Product Change Notification / SYST-05VUWX019

ERRATA - SAM D09 Family Silicon Errata and Data Sheet Clarification

SAM D09 Series Family Silicon Errata and Data Sheet Clarification

FIGURE 30-2: POR OPERATING PRINCIPLE:

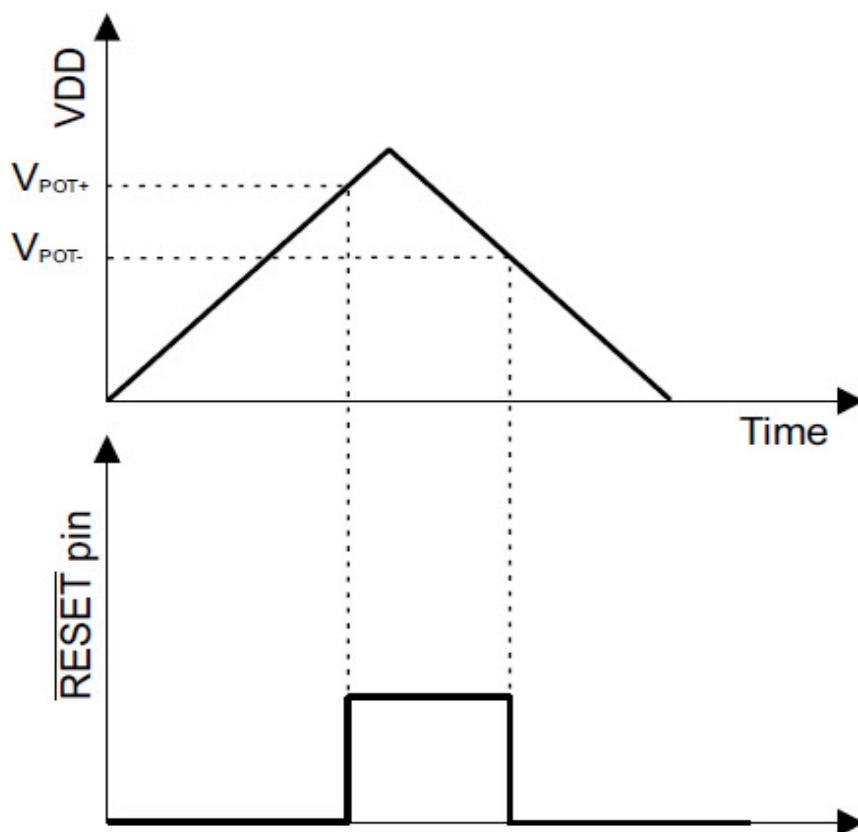
4. Module: Brown-out Detectors (BOD) Characteristics

Figure 30-2, 30-3, and Figure 30-4 have an incorrect reset Polarity value. The corrected figures are as shown below:
